CBD BUG Submission: Queensland Wharf Brisbane development application

The following comprises the Brisbane Central Business District Bicycle User Group (CBD BUG) submission on the Queensland Wharf Brisbane (QWB) development application (DA) (Reference number DEV2017/846).

Figure 7.2: Path widths for a 50/50 directional split

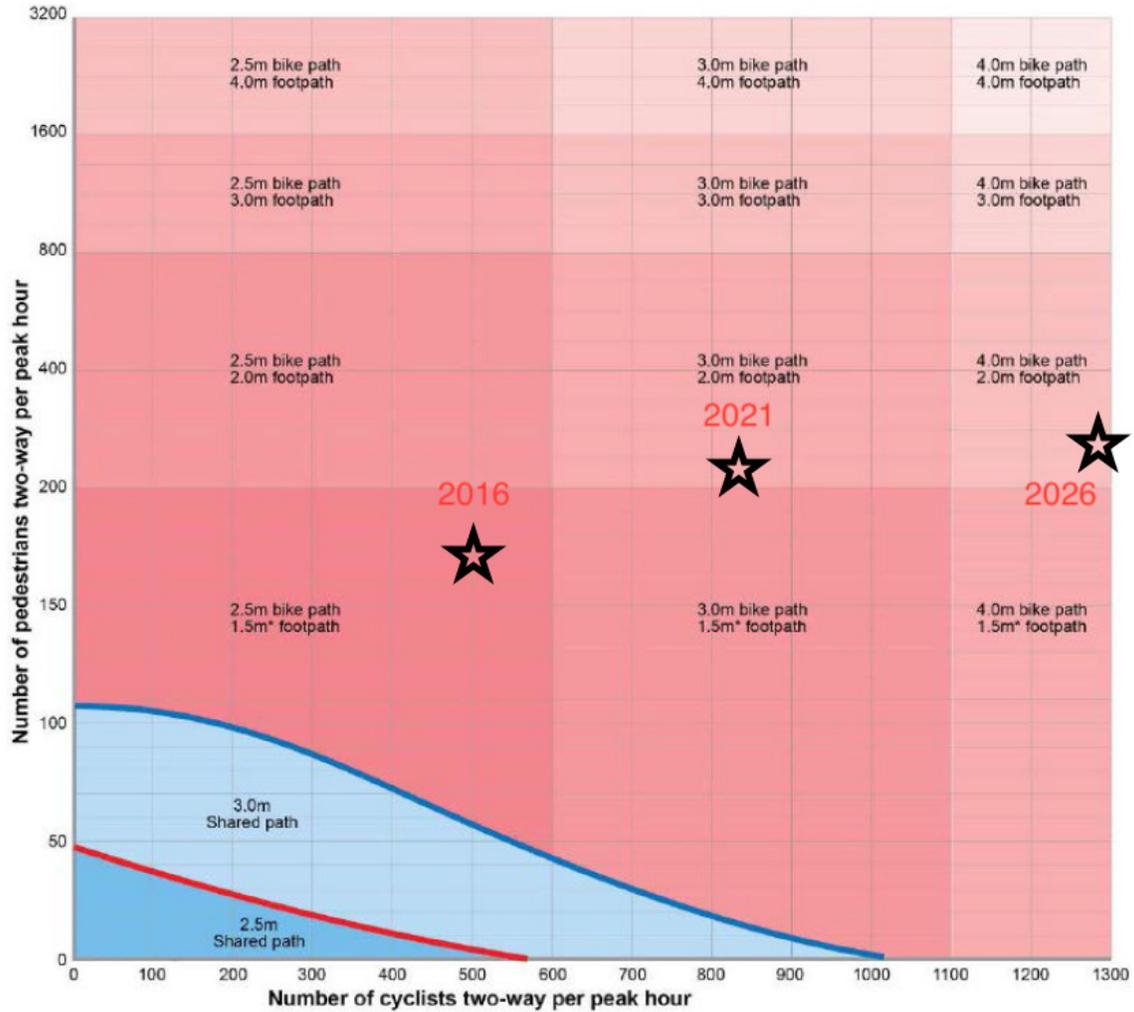
According to state and federal guidelines (*Transport and Main Roads and Austroads Cycling Guides 2017*) the only appropriate design for this area is to separate people walking from people cycling. The current situation is indicated by the star marked 2016 on the chart in the Appendix. This reflects 2016 volumes of 172 pedestrians and 519 cycles, east of Elizabeth Street during the AM peak on weekdays (as found in TTM's Traffic Report for the DA: “Surveyed Pedestrian and Cycle Volumes on Bicentennial Bikeway”).

If Brisbane City Council active transport strategy targets are to be met, walking and cycling numbers will increase in line with the projected population growth in the inner city, requiring separated paths. These numbers are marked on the chart in Appendix 1 to this submission. By 2021, a 3.0 metre bike path and 2.0 metre footpath is indicated and by 2026, a 4.0 metre bike path and 2.0 metre footpath is indicated.

A shared path is appropriate only for very low volumes of pedestrians. To try to force together high volumes of pedestrians and cyclists is only going to cause conflict and lead to legal liabilities for state government. The design is in total contradiction to the state and federal guidelines, given the high volumes of people in these inner-city locations.
